**SPADINA MUSEUM
GARAGE
REHABILITATION**
285 SPADINA ROAD TORONTO, ON

MECHANICAL TENDER ADDENDUM M-01

October 3, 2023

PROJECT: Spadina Museum Garage Rehabilitation and Site Accessibility
LOCATION: 285 Spadina Road, Toronto, ON M5R 2V5
Client Project #: A22048
M4S Project #: 22626

Drawing title
**BASEMENT – POWER &
SYSTEMS – DEMOLITION &
MODIFICATION**

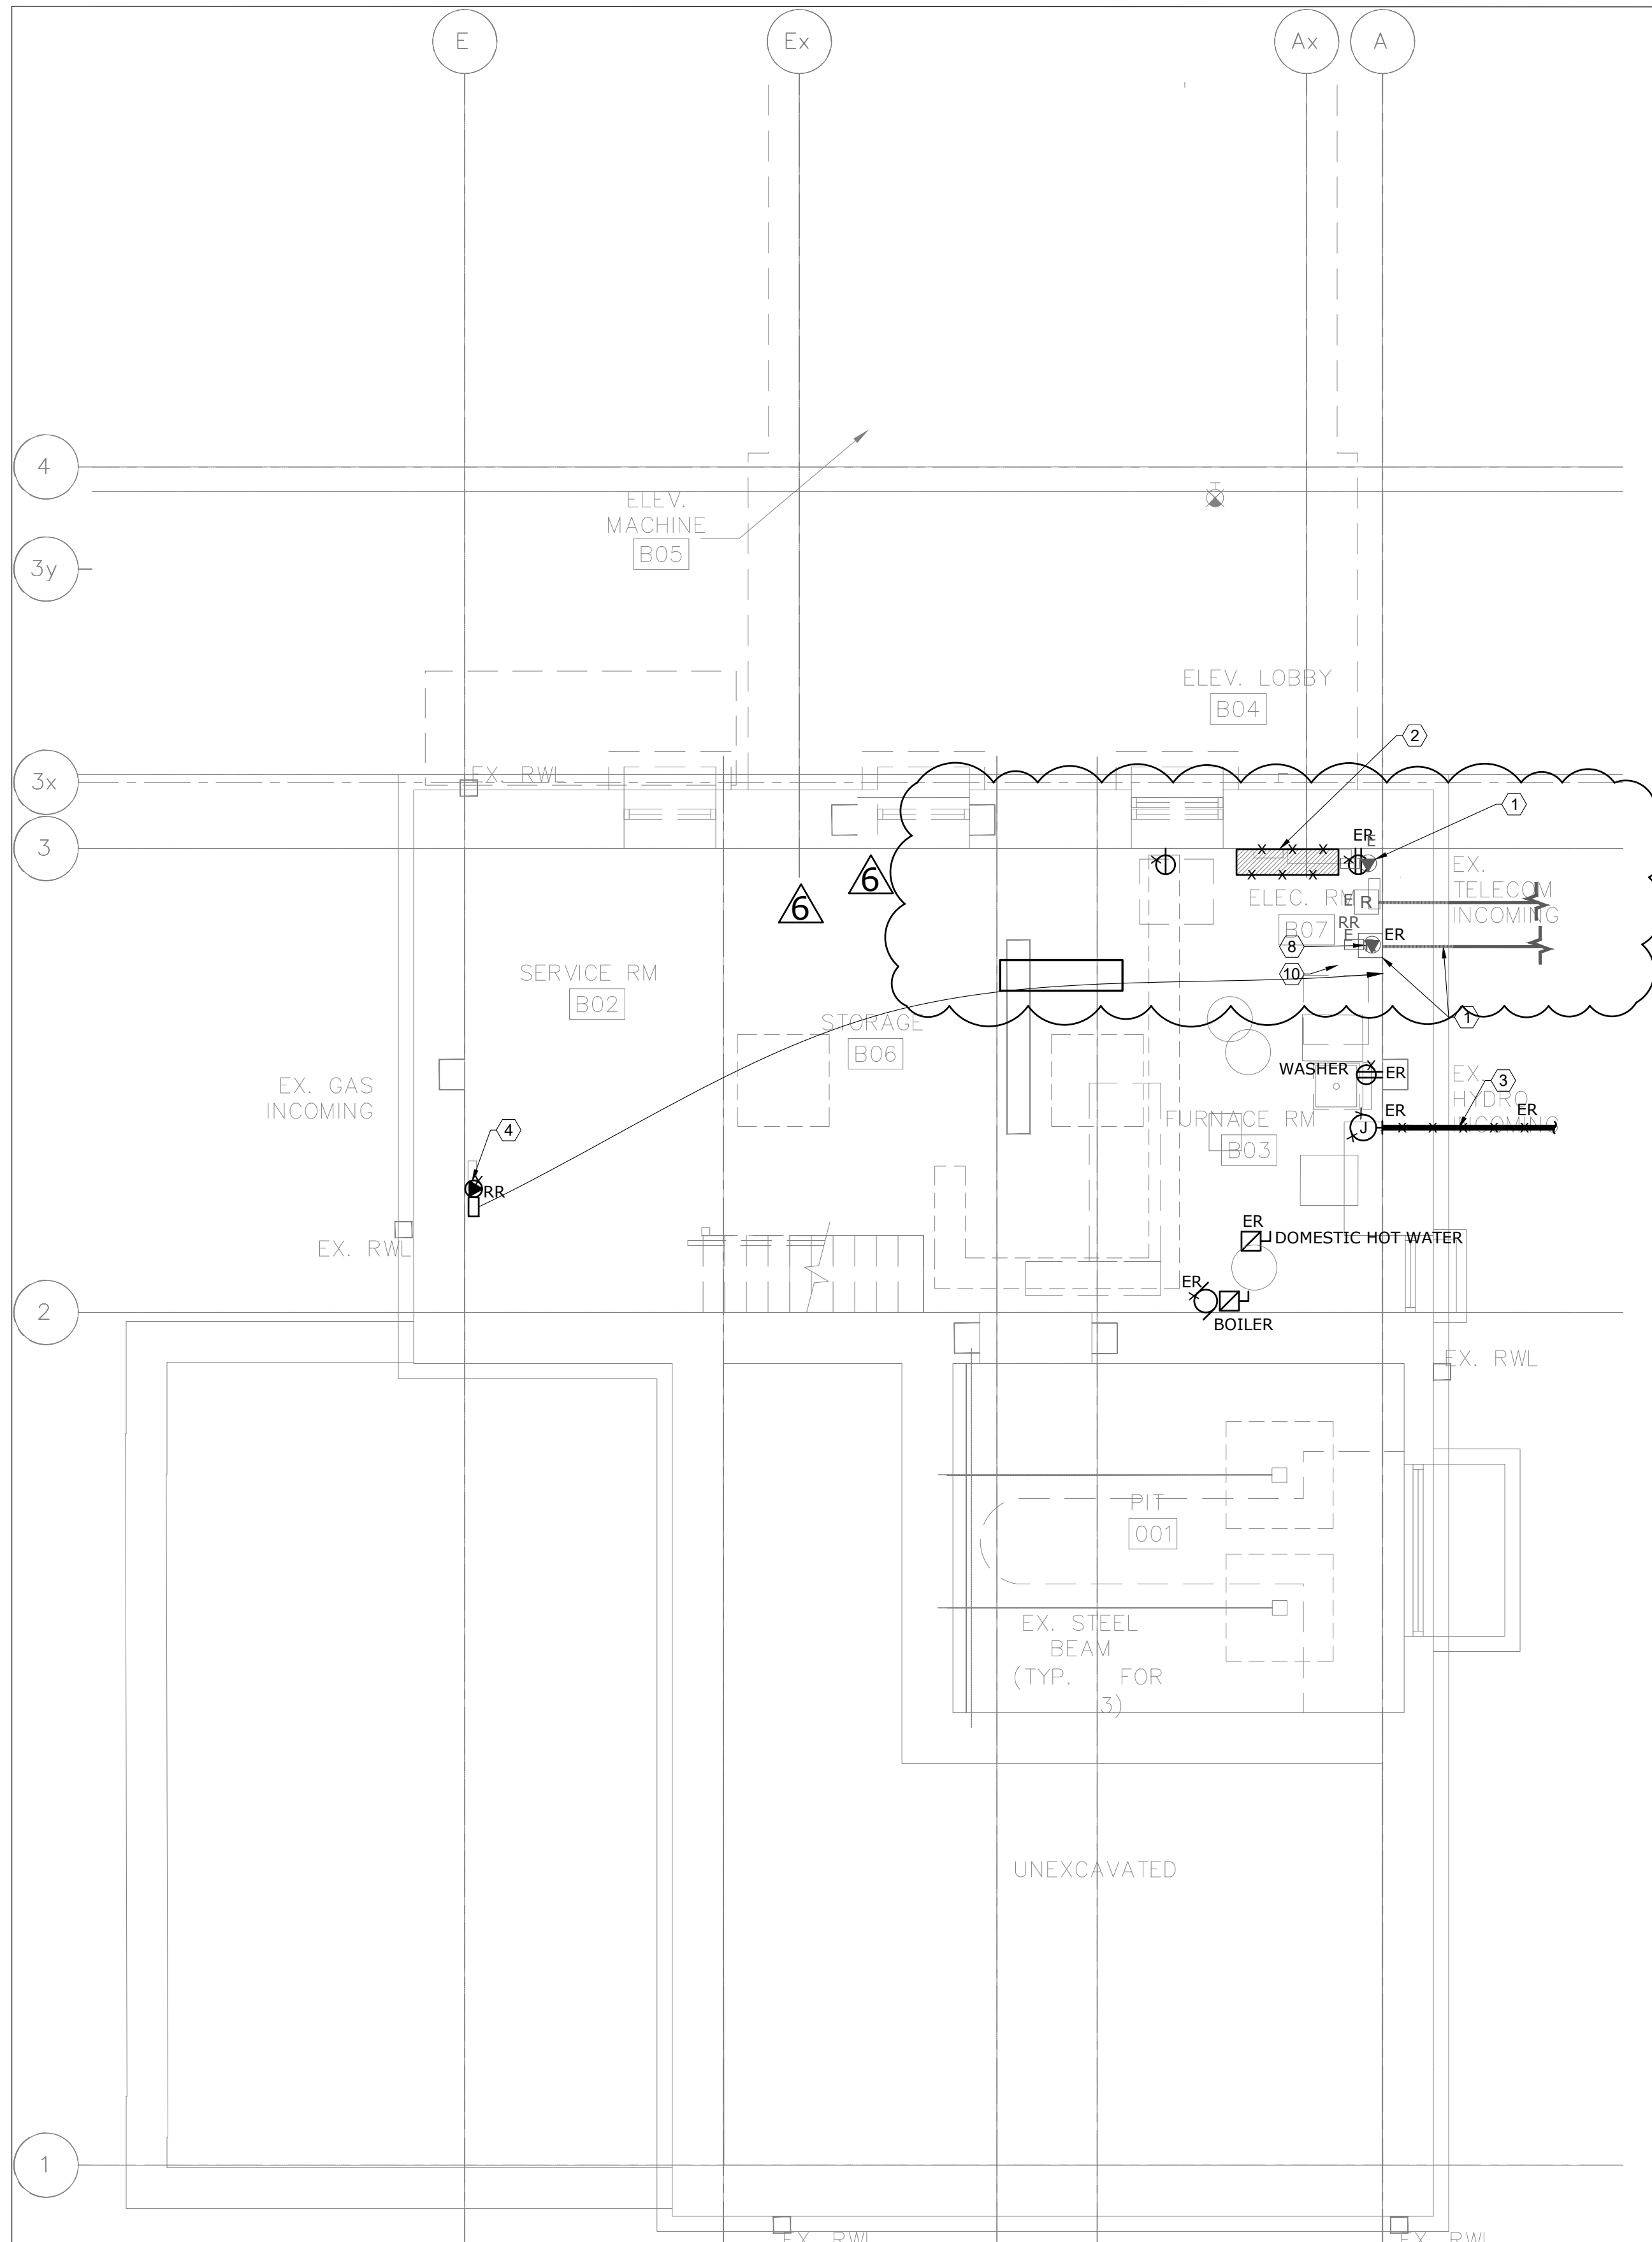
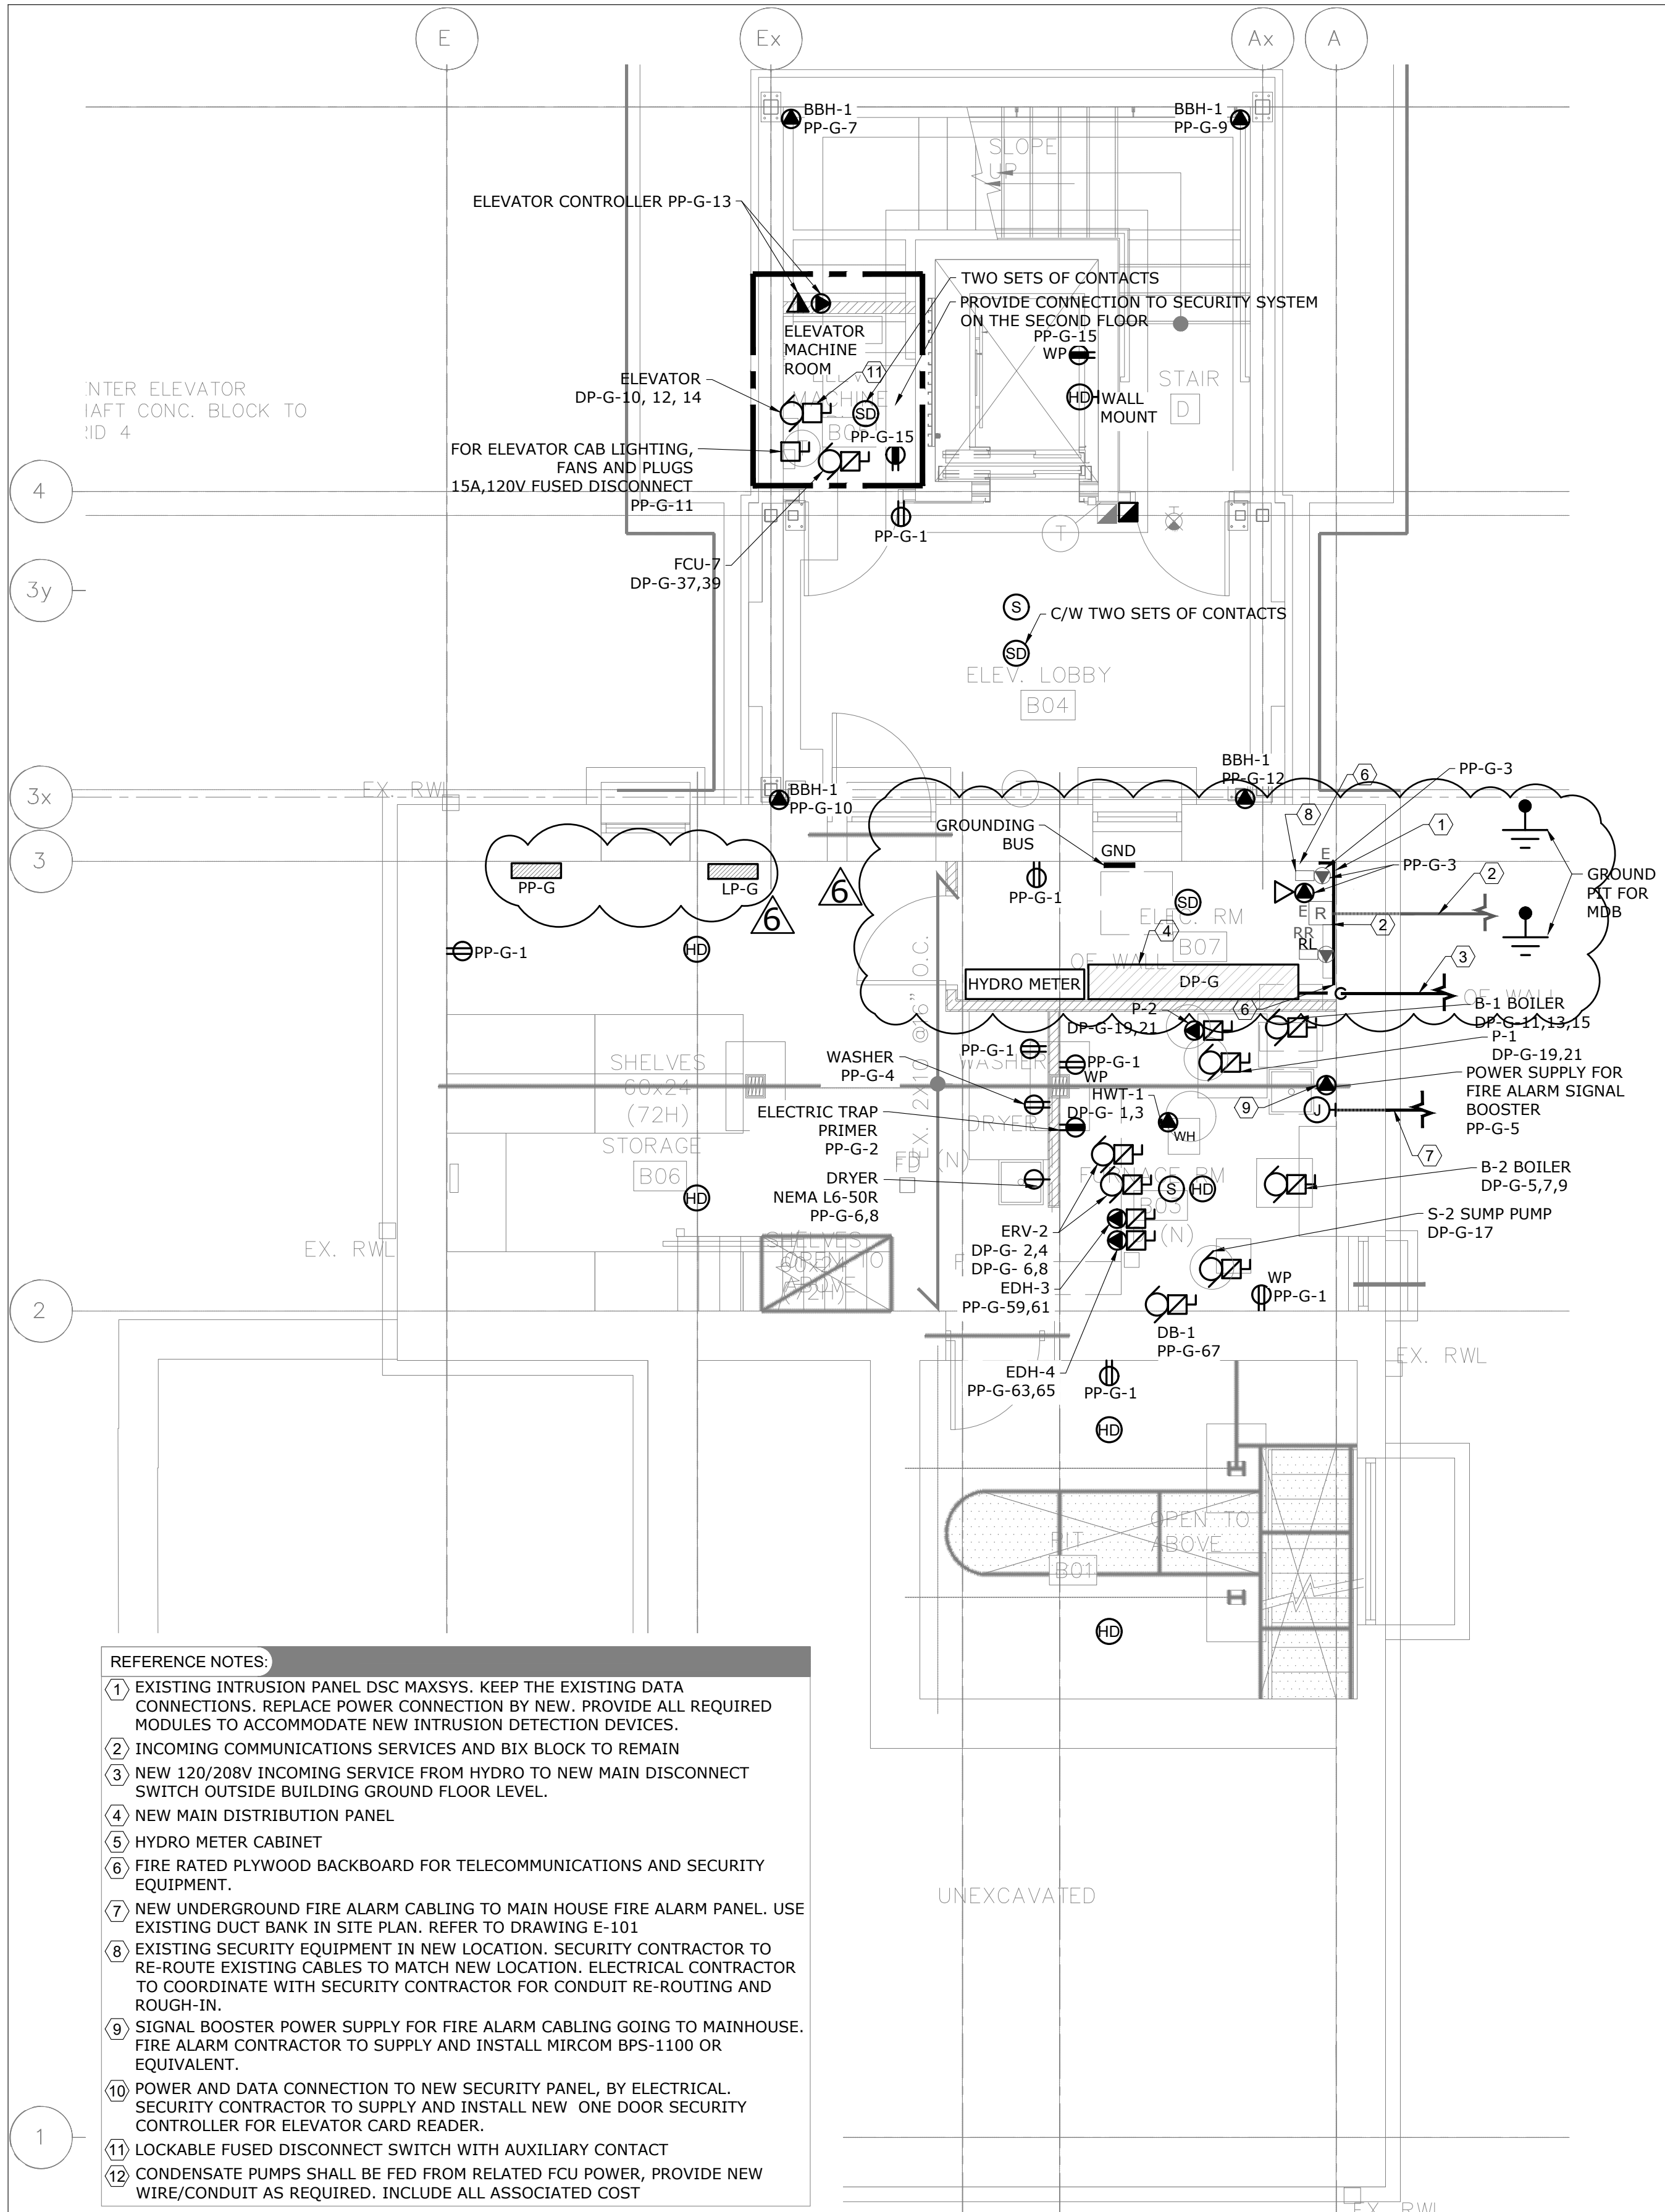
- Detail 2/E-202
 - Reference note #1 added.
 - Lighting c/w occupancy sensor added in Janitor room.
 - **Dwg. E-300**
 - Detail 1/E-300
 - Demolition for existing electrical room revised.

- Detail 2/E-300
 - Layout of electrical room revised; panel locations modified.
- **Dwg. E-301**
 - Detail 2/E-301
 - Reference note #10 added.
- **Dwg. E-302**
 - Detail 2/E-302
 - Reference note #1 added.
 - Heat detector added in Janitor room.
- **Dwg. E-900**
 - Detail 2/E-900
 - Secondary conductor specified, c/w switchboard and Hydro metering.
